Master Development Drainage Plan &
Preliminary Drainage Report
Monument Ridge East
El Paso County, Colorado

SP241

August 5, 2024

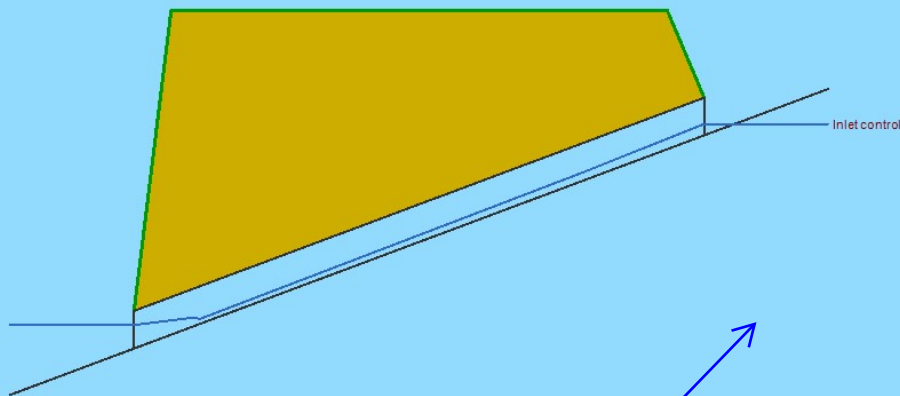
why is this all blue?

DETENTION BASIN OUTLET STRUCTURE DESIGN

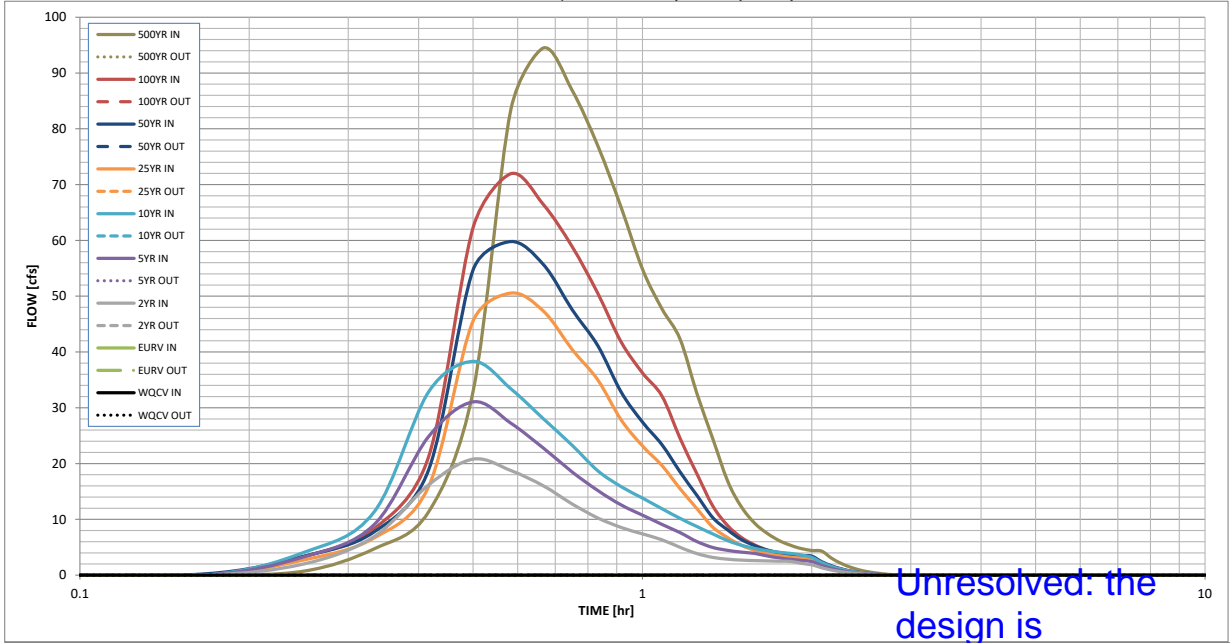
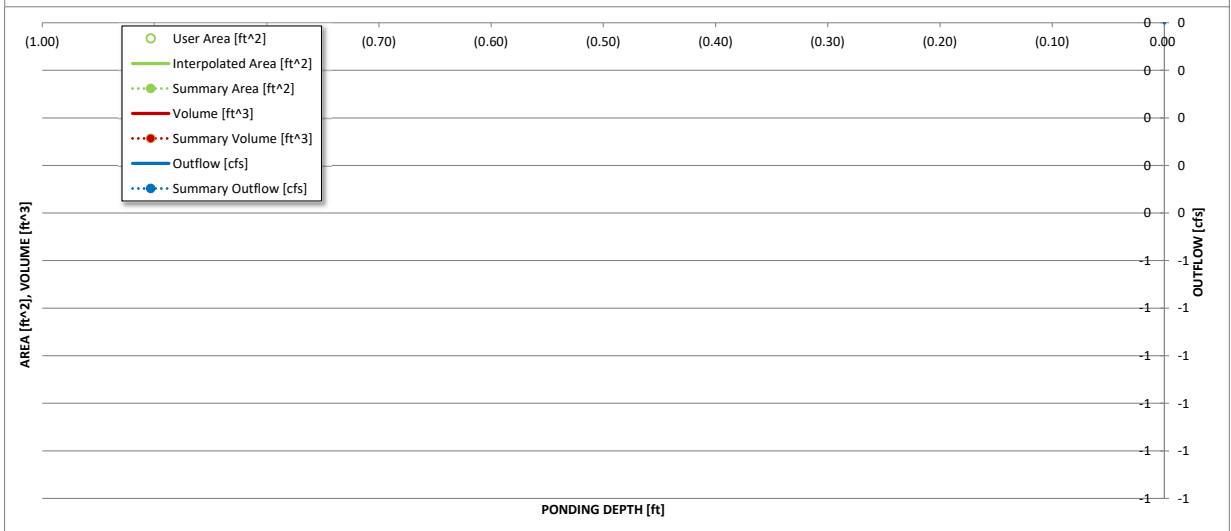
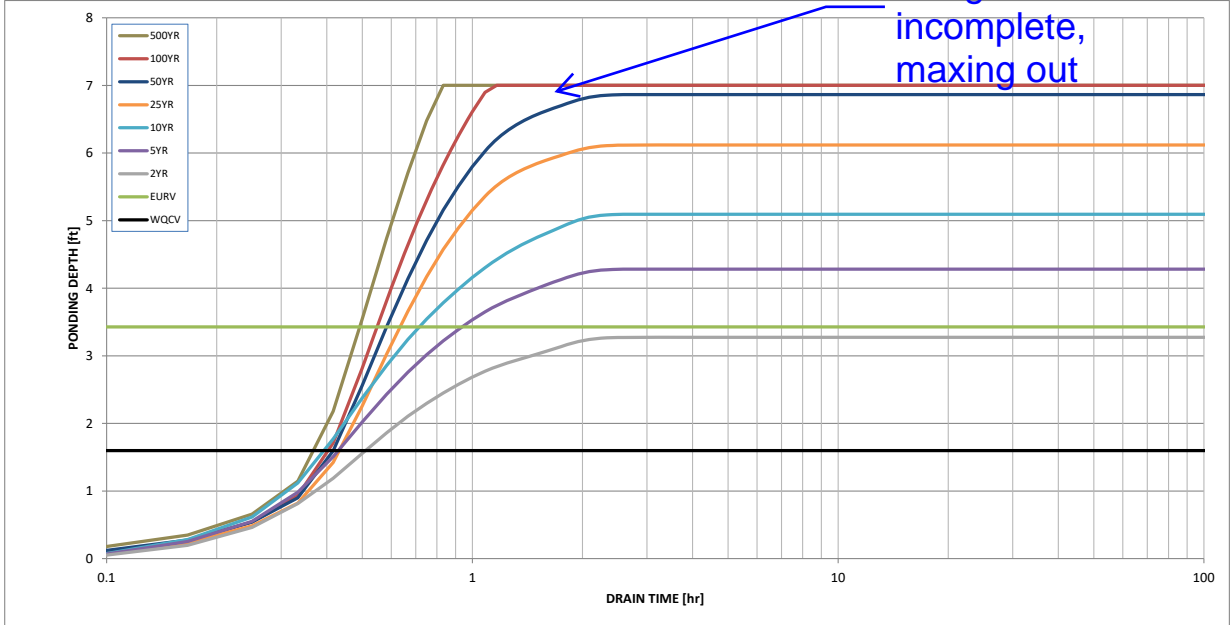
Unresolved: provide all preliminary design data

Unresolved: the design is incomplete, maxing out

DETENTION BASIN OUTLET STRUCTURE DESIGN

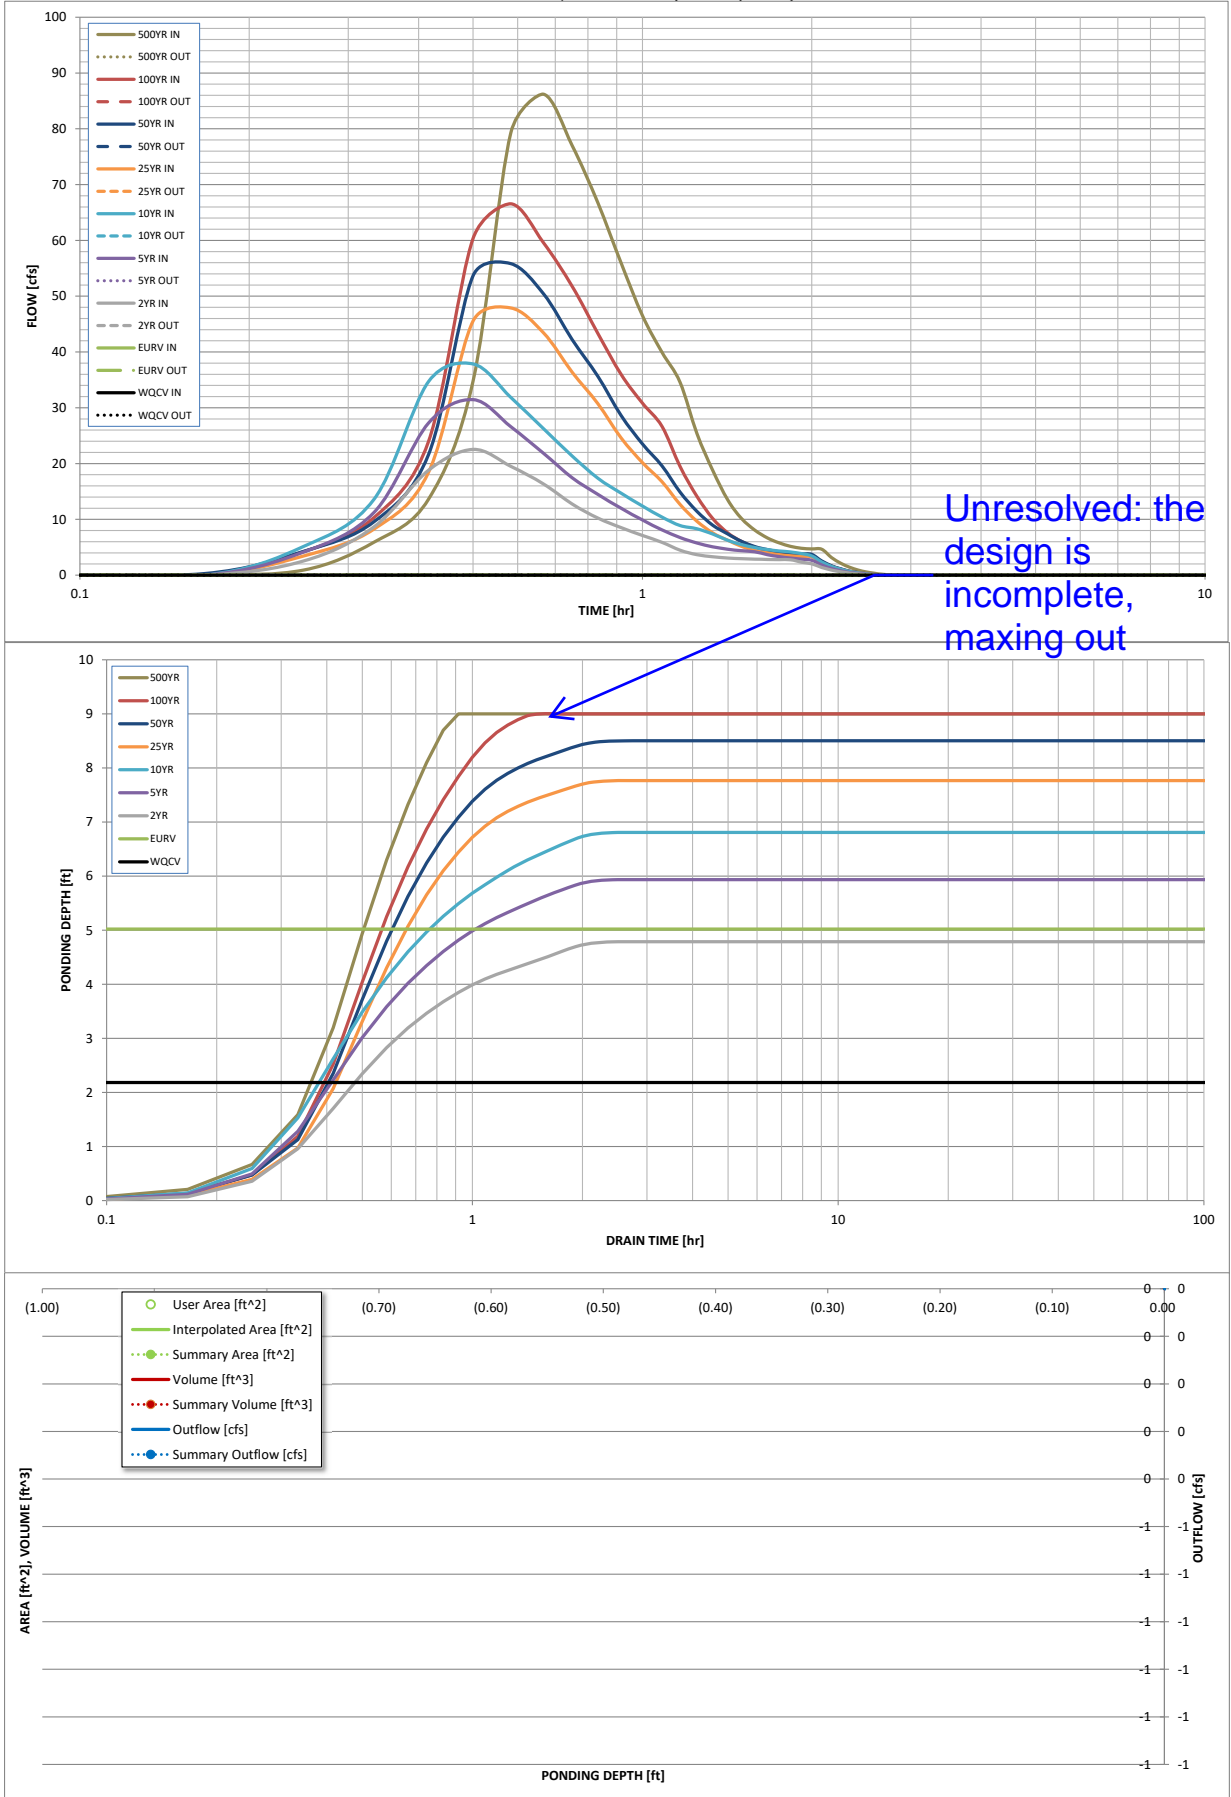
Unresolved: provide all preliminary design data

DETENTION BASIN OUTLET STRUCTURE DESIGN

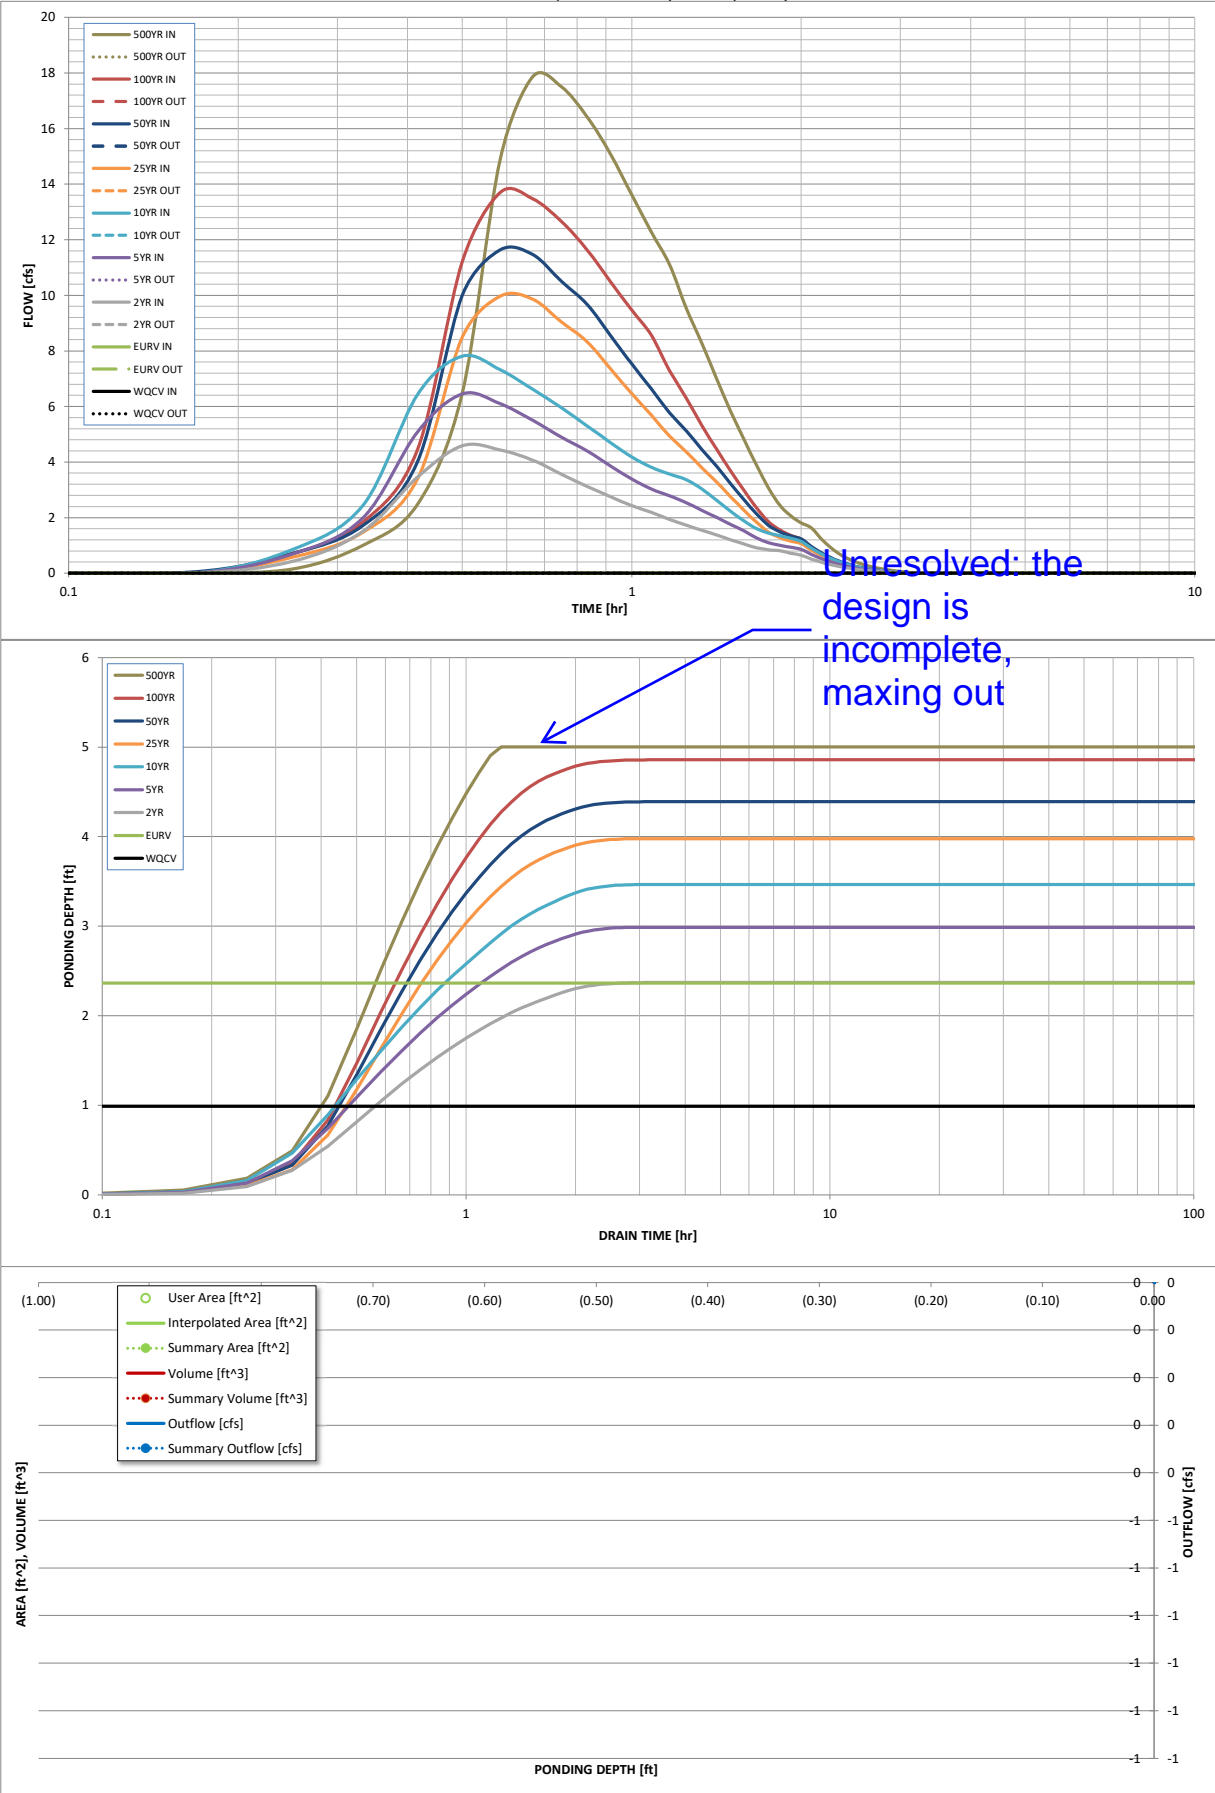
Unresolved: provide all preliminary design data

DETENTION BASIN OUTLET STRUCTURE DESIGN

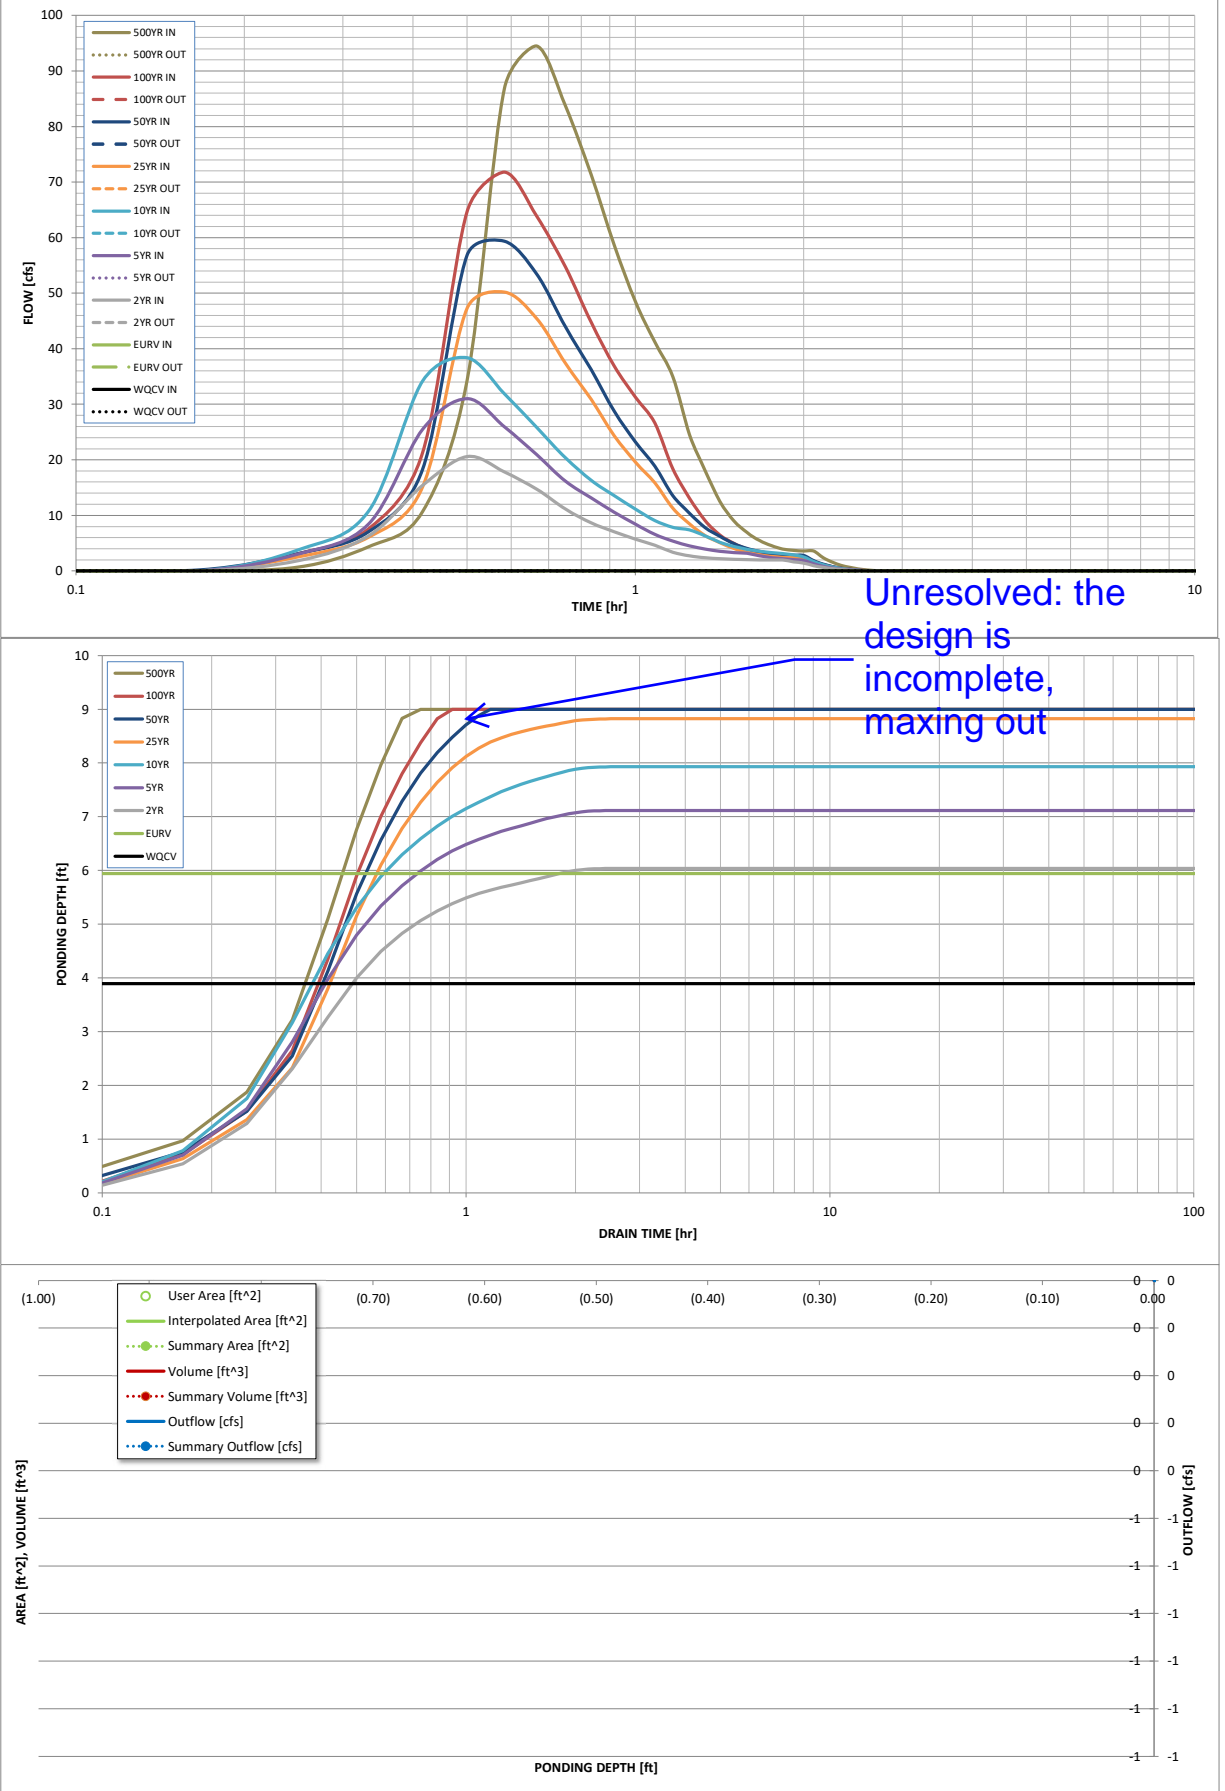
Unresolved: provide all preliminary design data

DETENTION BASIN OUTLET STRUCTURE DESIGN

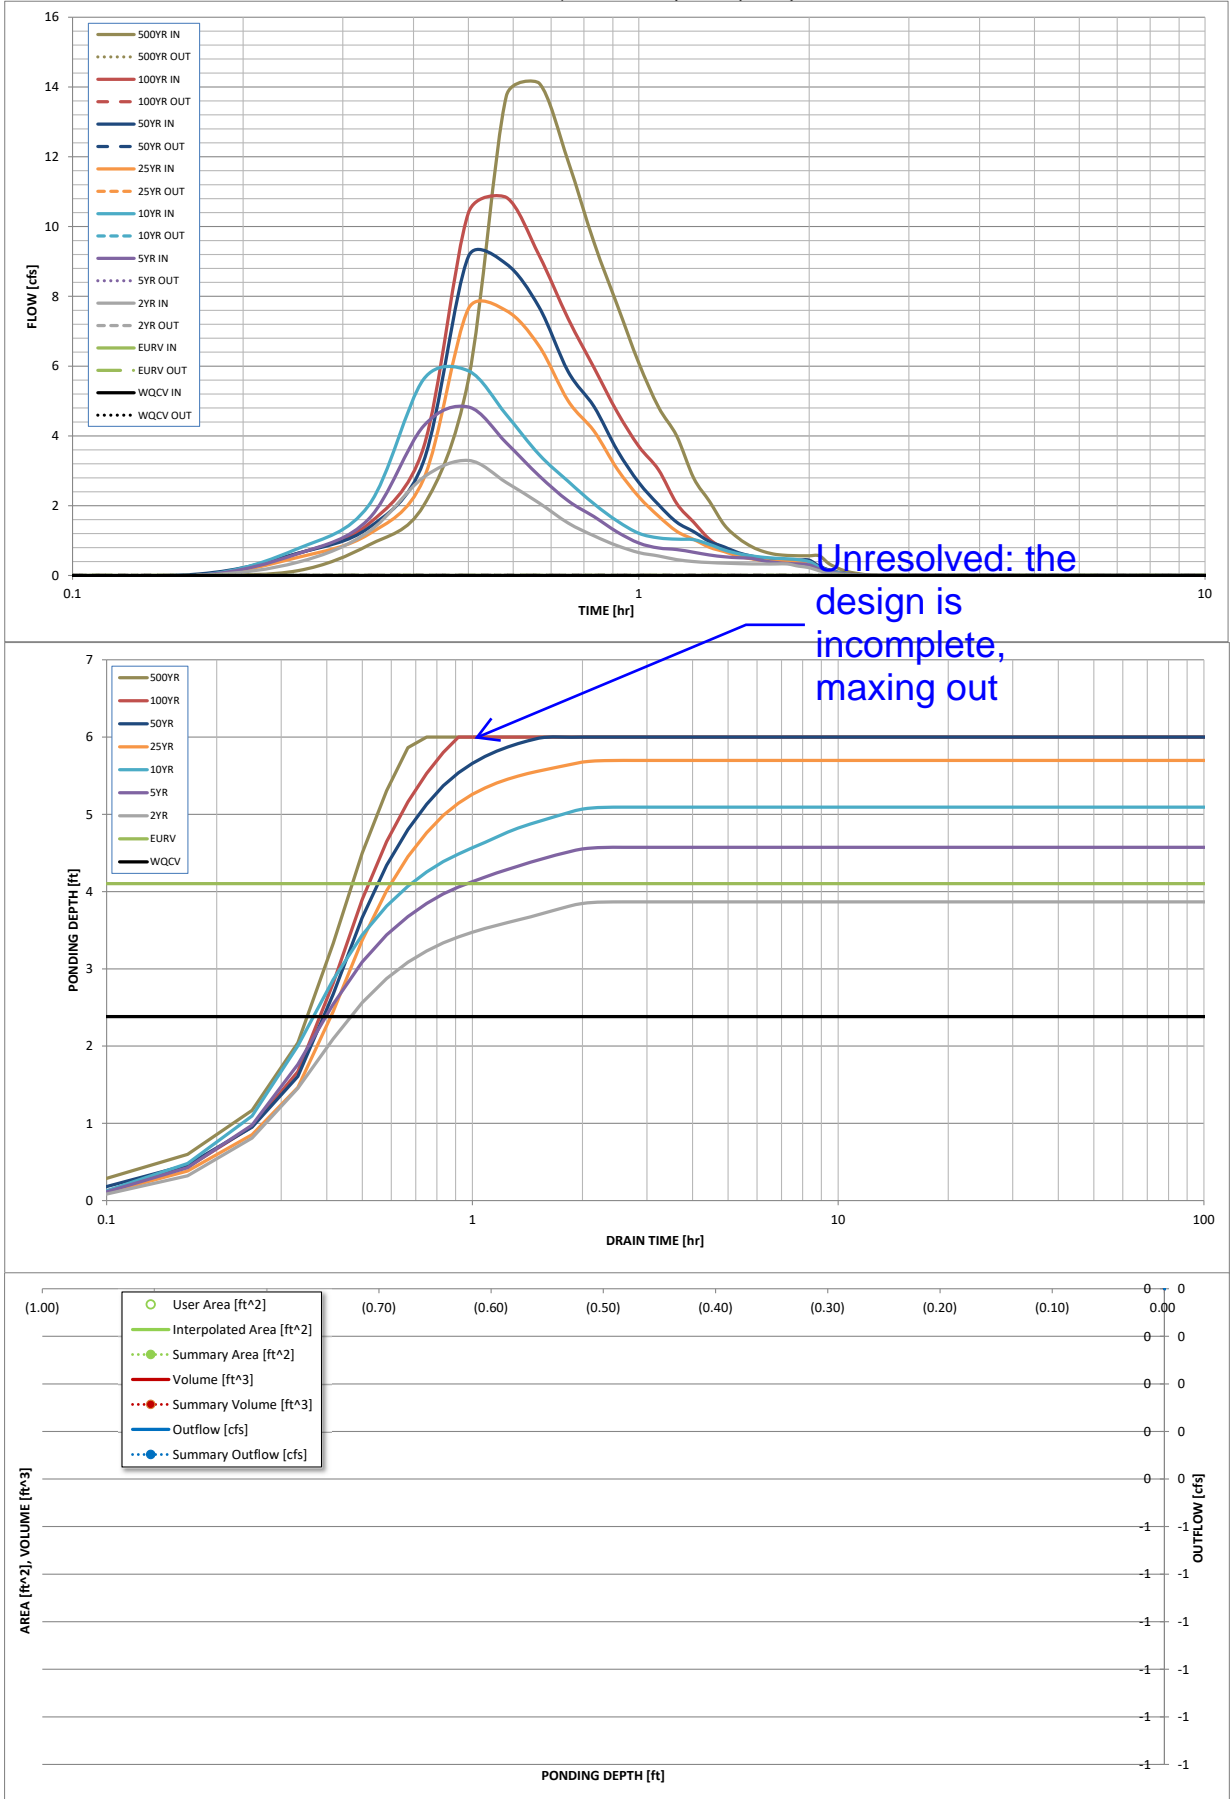
Unresolved: provide all preliminary design data
